REVISIONS	<i>GRINDER PUMP SKETCH</i>	TOWN OF GROTON WPCD GARY CT, GROTON
	ADDRESS: 66 RIVERVIEW AVE	
	NOANK	
DWG: RIVERV66	OWNER: JOHN & PAT RATHBUN

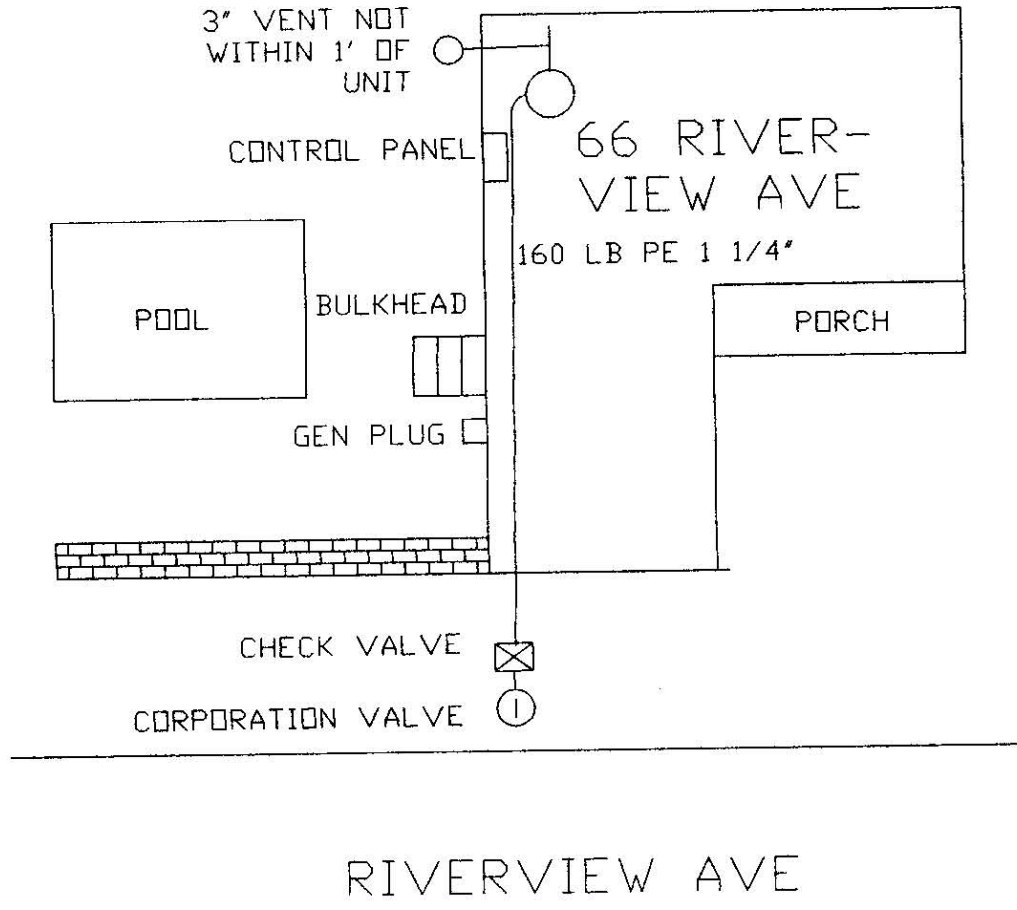
NOTE: HEADROOM IS CLOSE AND CORE WILL NEED TO BE TIPPED TO GET OUT OF THE UNIT. OWNER DID NOT INSTALL VENT WITHIN 1' OF THE UNIT. IF THERE IS A PROBLEM WITH THE ALARM THEN HE WILL HAVE TO CORRECT IT.

NOTE: OWNER WILL NEED SOME CLEANDUTS IN THE 3" WASTE LINE, NOT THE WAY I WOULD LIKE IT DONE BUT TO PULL EVERYTHING APART NOW COULD CREATE A HARDSHIP.
